SUBJECT: DRAFT ENVIRONMENTAL ASSESSMENT AND SAFETY EVALUATION
REPORT FOR CABOT-REVERE SITE

SUBJECT: SAFETY EVALUATION REPORT, SITE
DECOMMISSIONING PLAN AND RADIOLOGICAL
ASSESSMENT DATED FEBRUARY 28, 2001

**DRAFT ENVIRONMENTAL ASSESSMENT
OF SITE DECOMMISSIONING PLAN AND RADIOLOGICAL ASSESSMENT
FOR CABOT PERFORMANCE MATERIALS, REVERE, PA**

Figure 1. Generalized conceptual model used in the Cabot-Revere assessment.

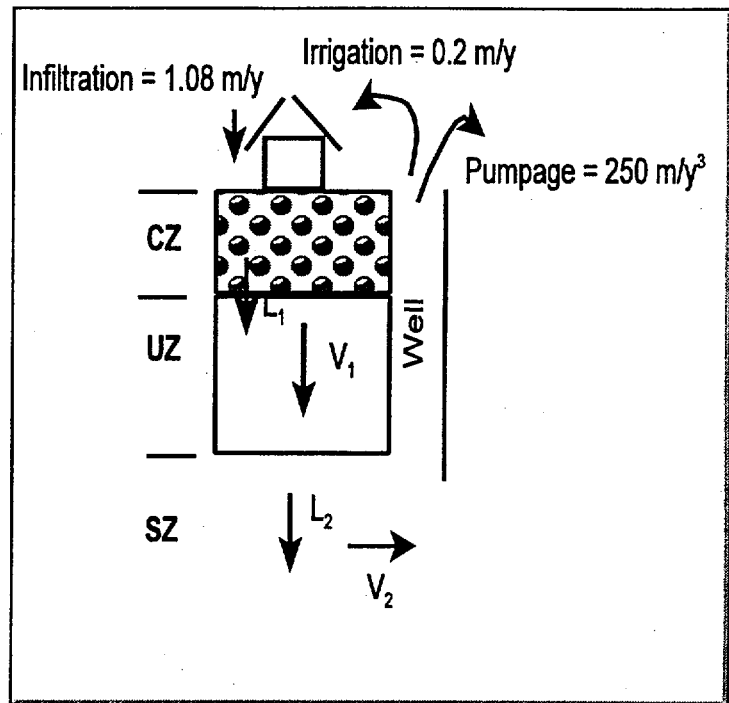
Figure 1 shows a schematic of the general conceptual model used in the Cabot-Revere radiological assessment, based upon staff's interpretation of the information presented in the report.

It should be noted that a default irrigation rate of 0.2 m/y was used in the analysis although the licensee only assumed irrigation as part of their residential gardener scenario.

Based on regional information, the unsaturated zone is believed to be roughly 20 meters thick; however, for the assessment nominal credit is taken for the possible hold-up of contaminants migrating through the unsaturated zone. This is reflected by the small unsaturated zone thickness (0.01 m) assumed for the analysis. Staff believes that this adds conservatism to the calculated doses for the water-dependent pathways.
